NEW FIRE STATION: ENGINE CO. 268 / LADDER CO. 137

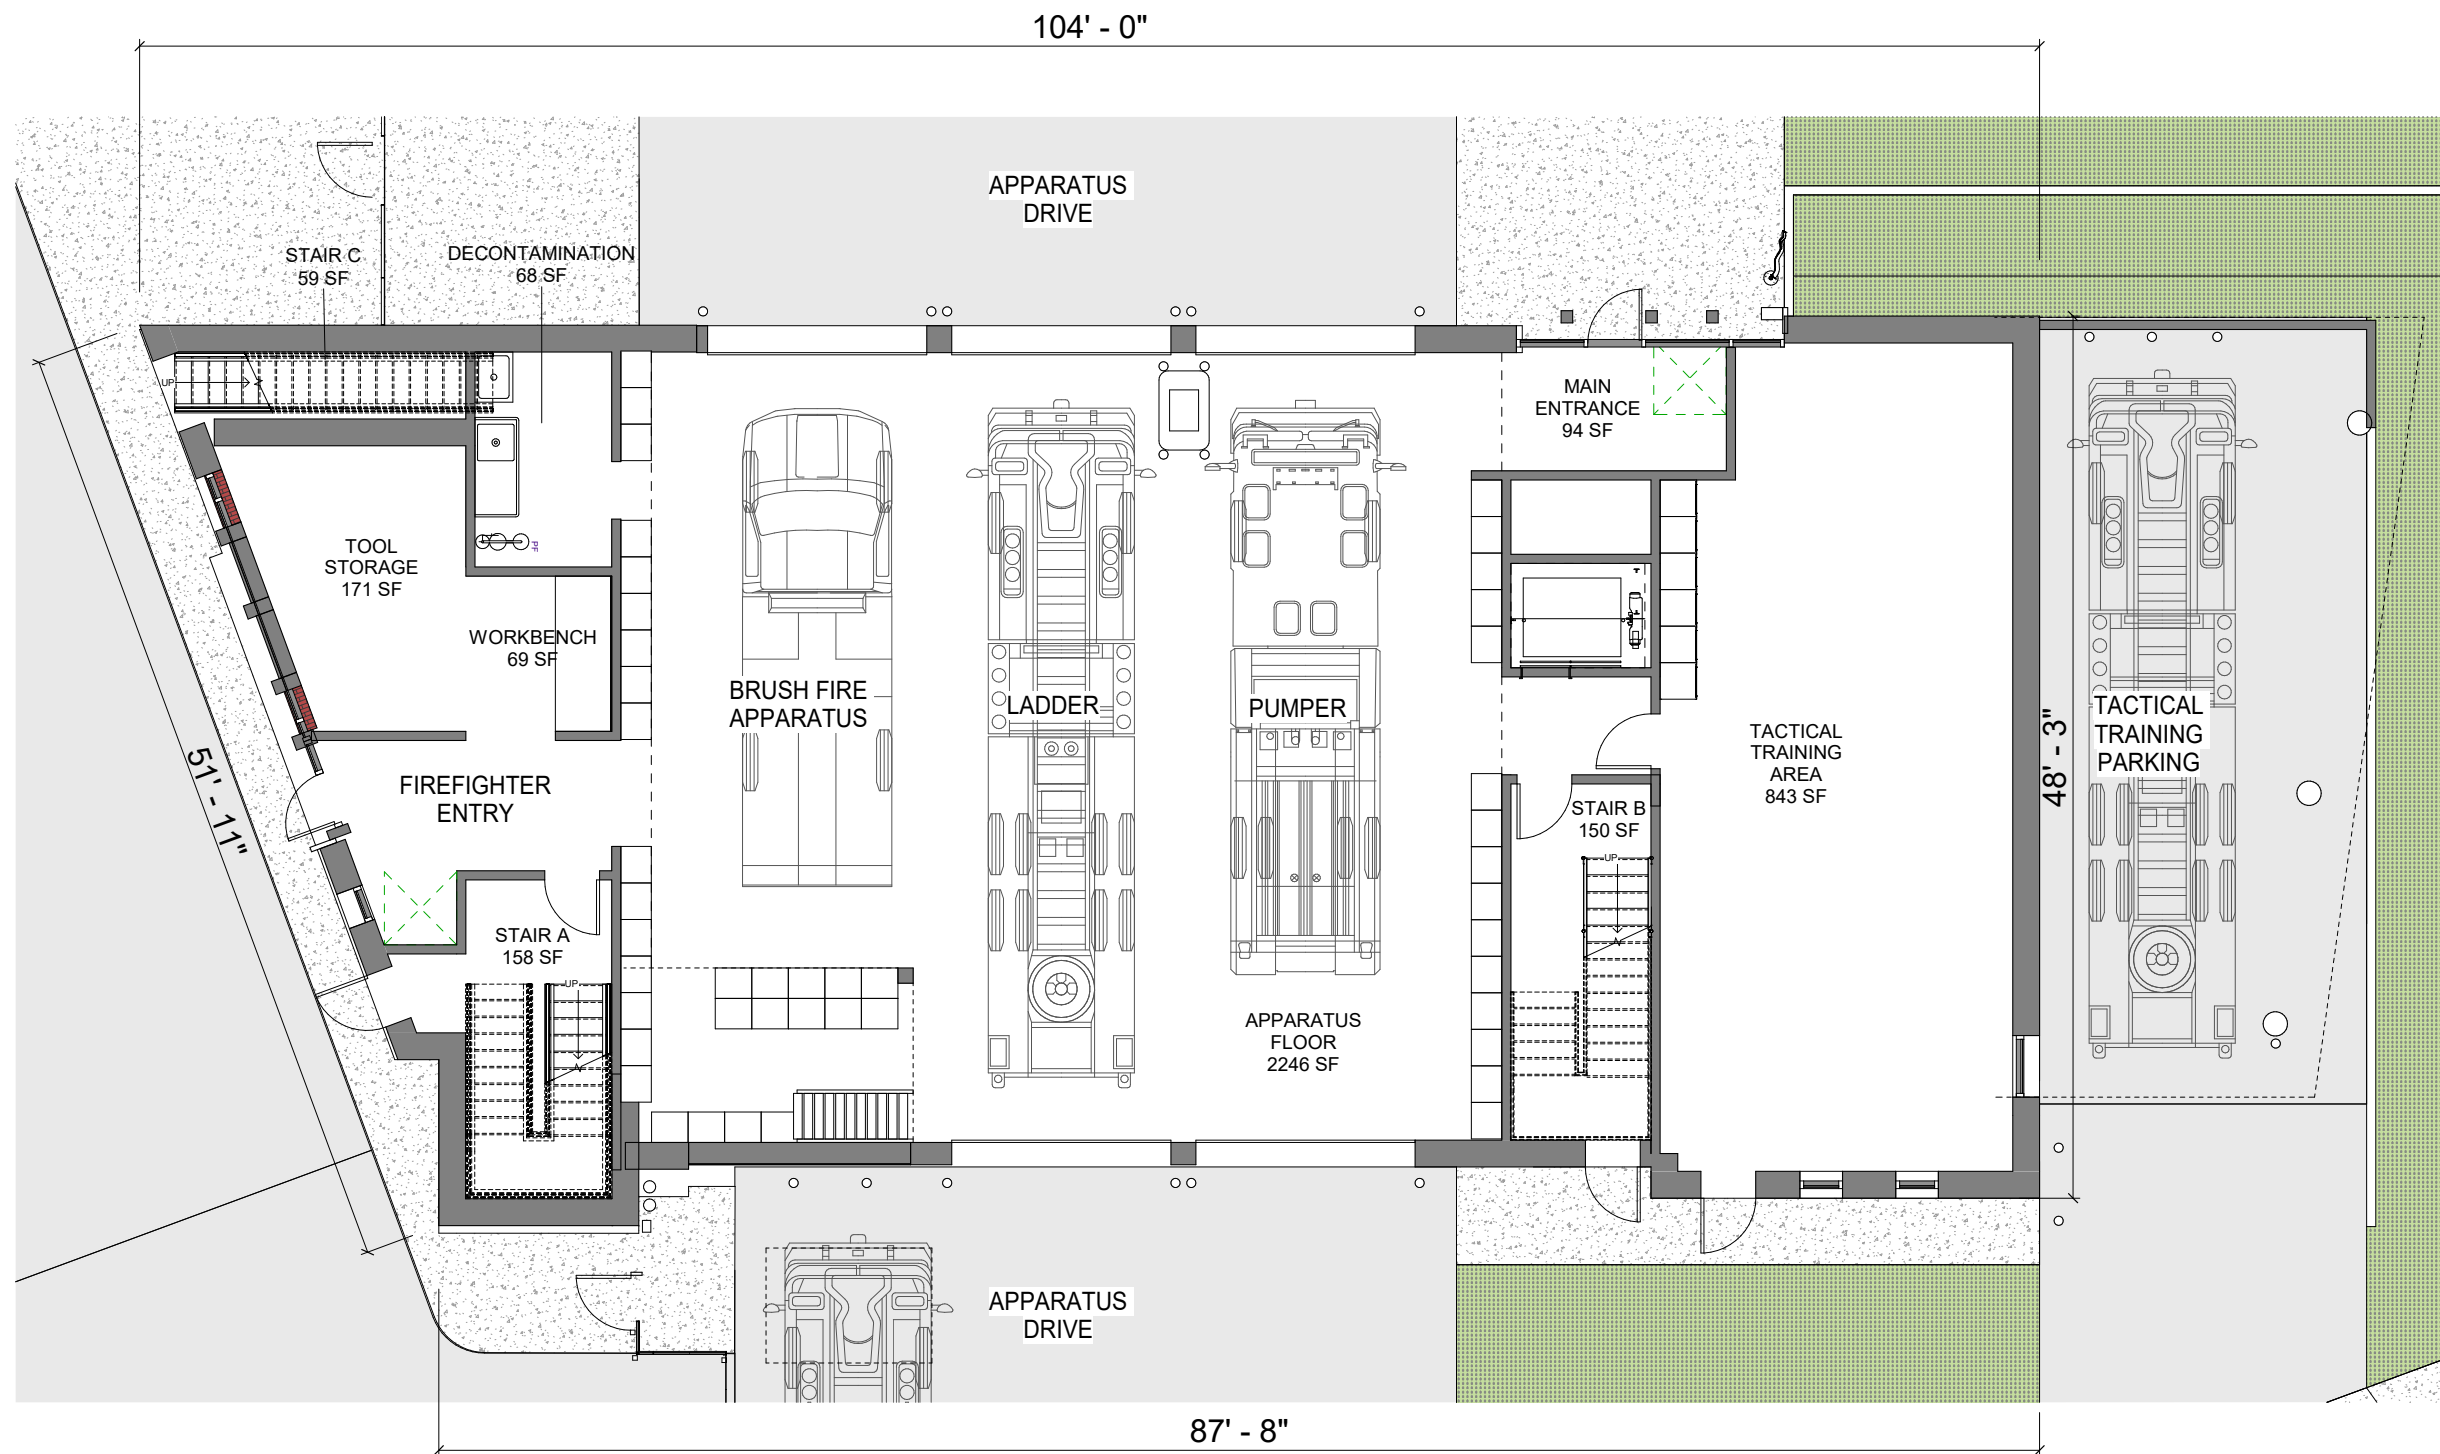
R6 - FLAT BOTTOM BOAT STORAGE ADDED BEHIND LANDSCAPE MASONRY WALL

R1 - VEGETATIVE FENCE ADDED TO DESIGN AROUND PARKING AREA

R2 - EXTERIOR BIKE PARKING ADDED

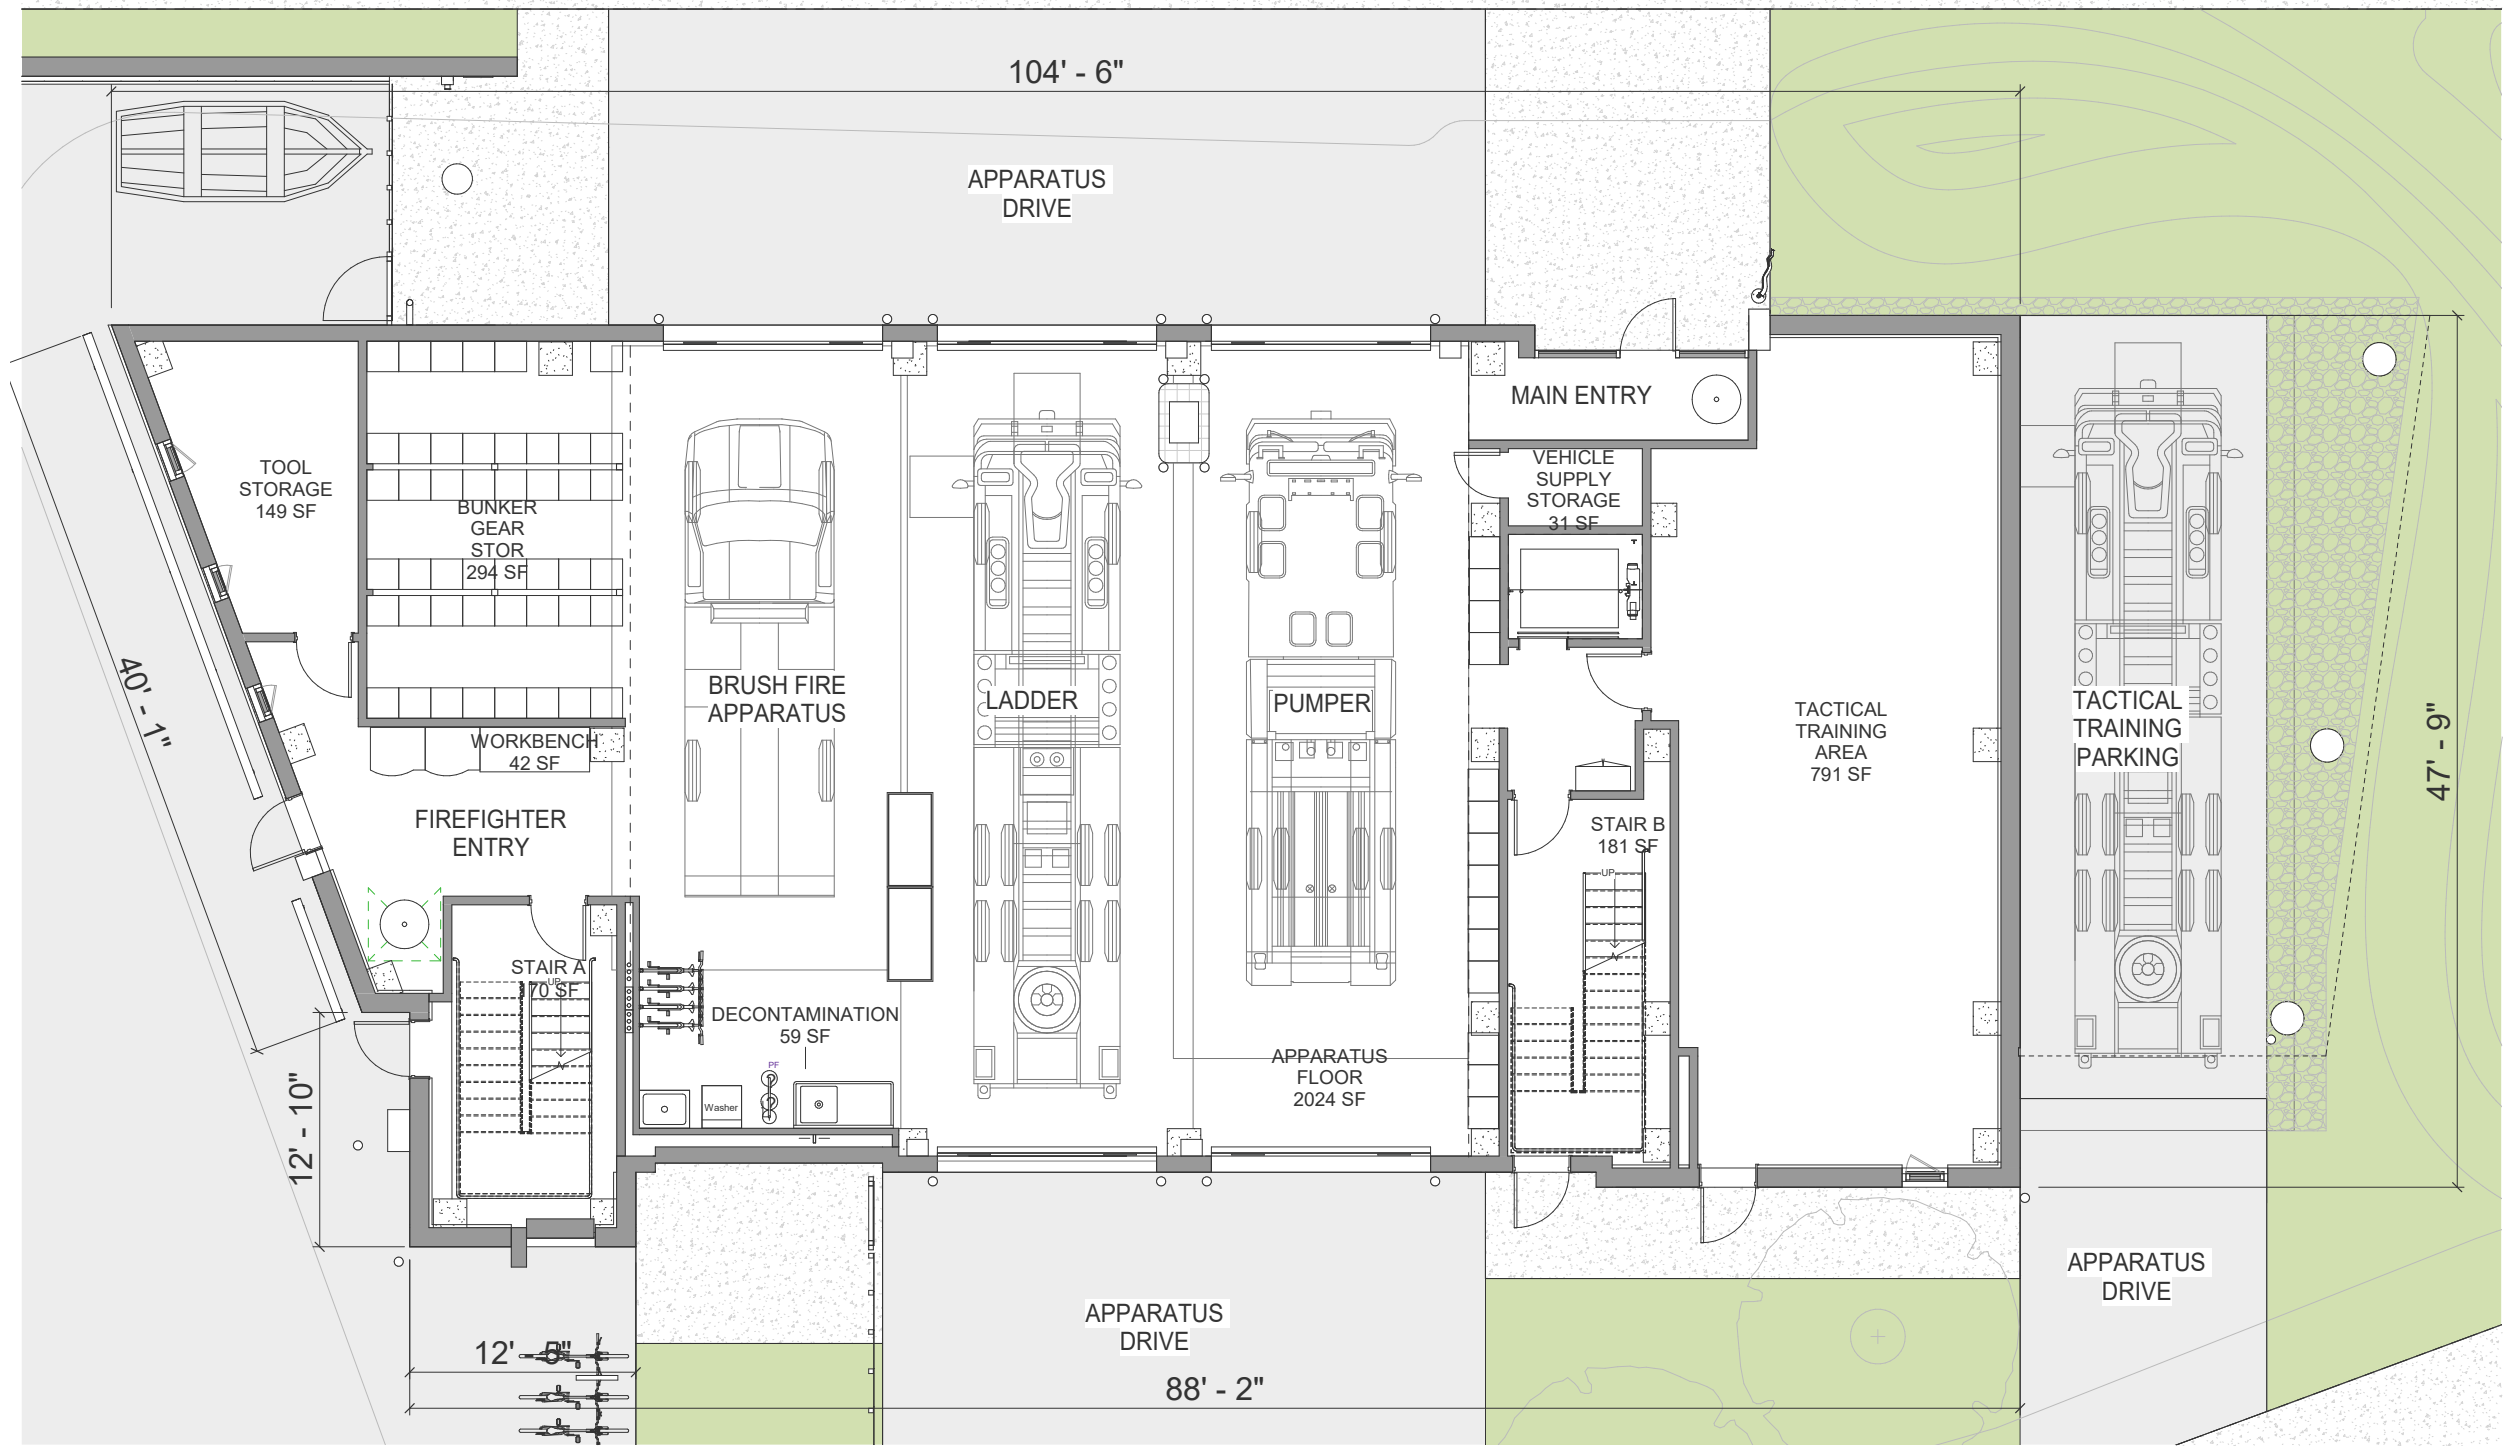
R3 - DUMPSTER AREA, ACCESS GATE, AND SURROUNDING FENCE ADDED

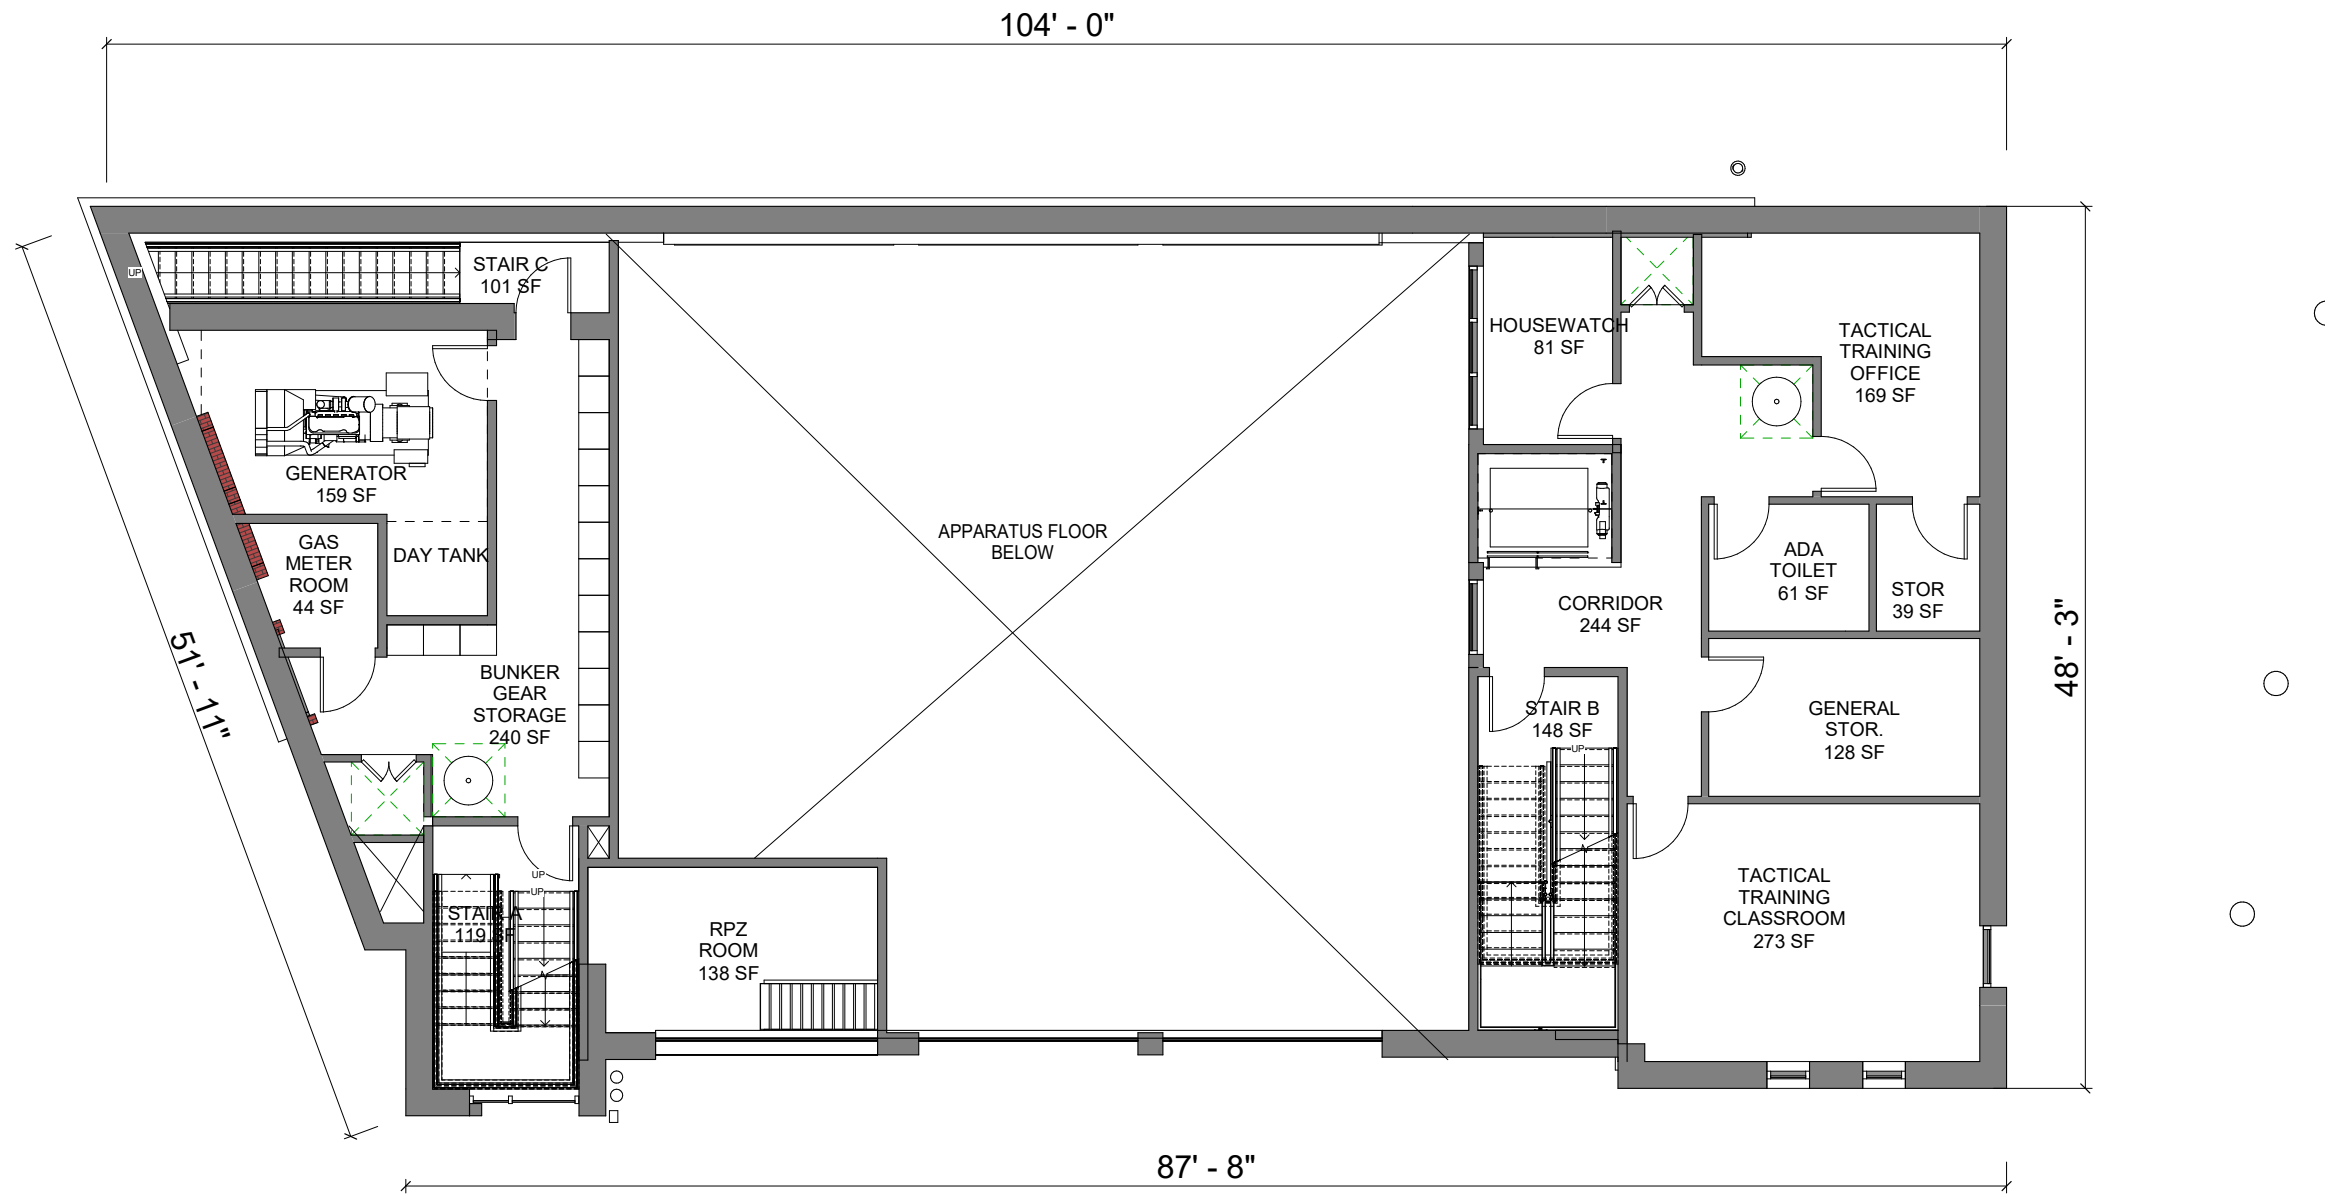
R4 - STREET TREE LOCATIONS REVISED. 7 NEW STREET TREES LOCATED ON SIDEWALK

R5 - UPDATED EAST LANDSCAPE AREA WITH EARTH BERMS

3 NEW TREES LOCATED WITHIN PROPERTY LINE
